ADDENDUM NO. 6

LOXAHATCHEE RIVER DISTRICT

Science Center at Jupiter Inlet Lighthouse Outstanding Area

PROJECT NO. ITB # 22-009-00119

DRAWING NUMBER
S-201

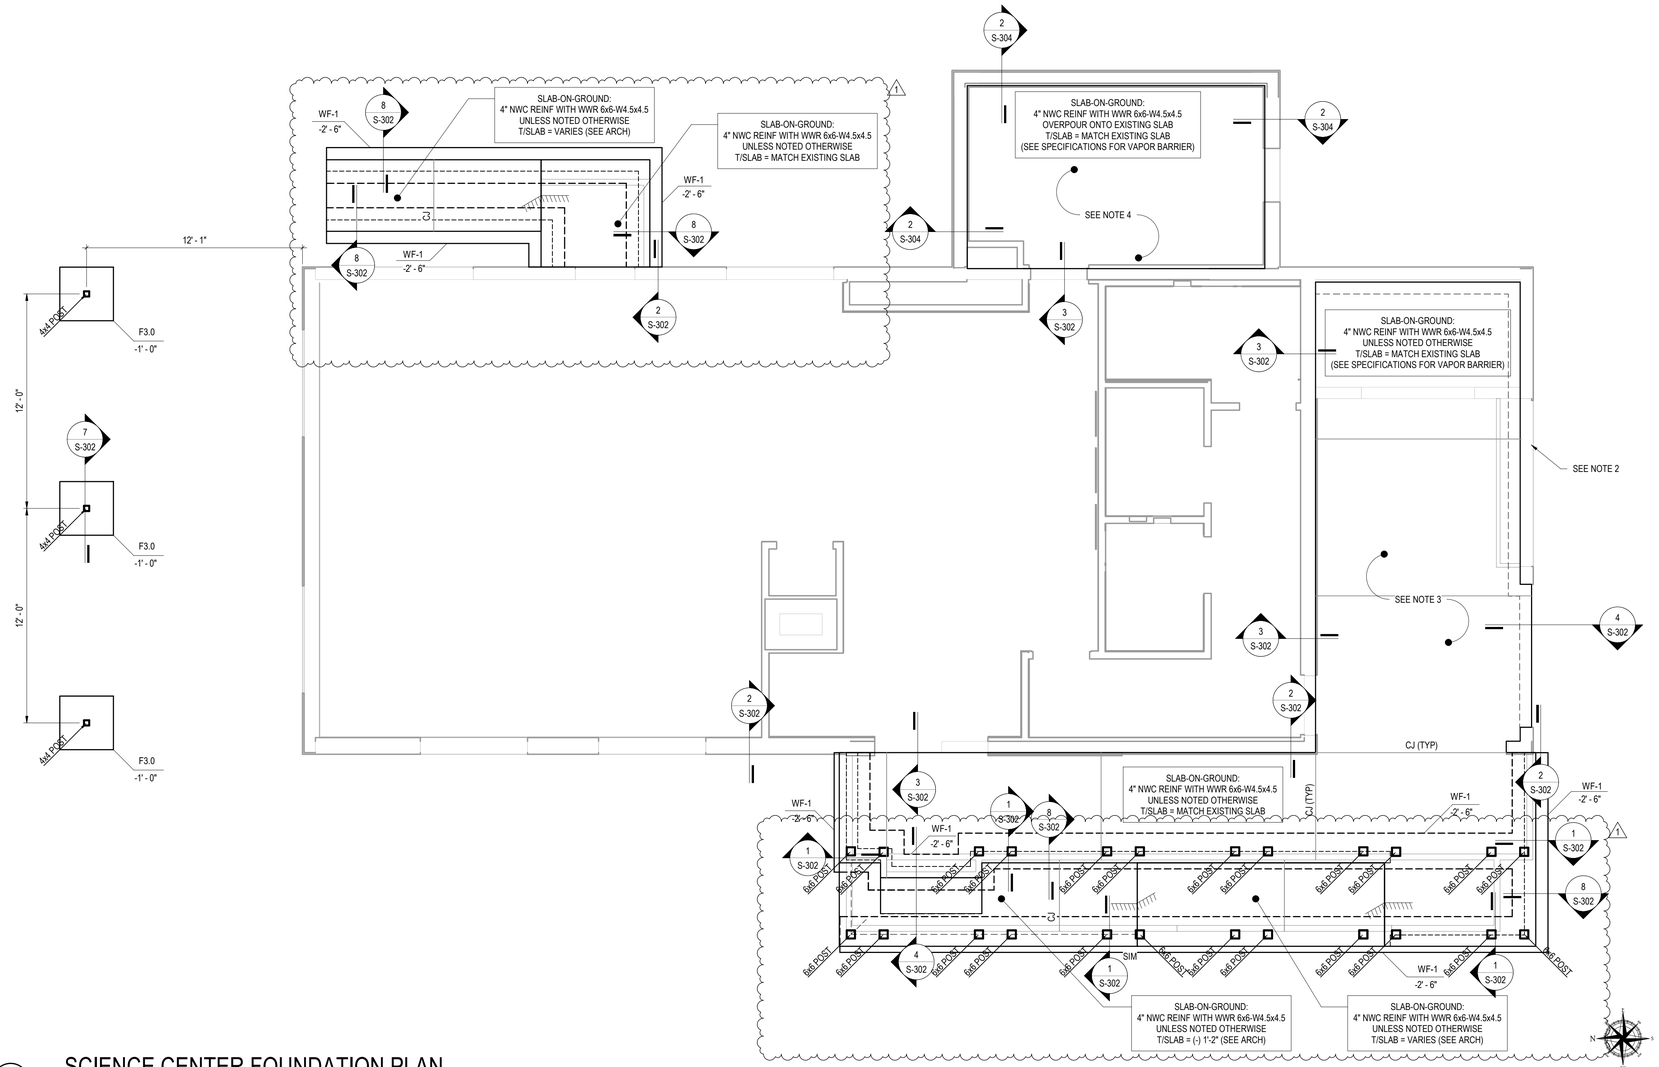
Q22 - Architectural Plans sheet AF 2.10 & and sheet A4.02 shows an exit ramp to be constructed at the east side of the Science building. Structural sheet S 2.01 does not show any structural detail for the ramp construction. Please provide structural detail for this exit ramp?
A22 – Access ramp detail has been included with this Addendum on Sheet S-201 and S-302.
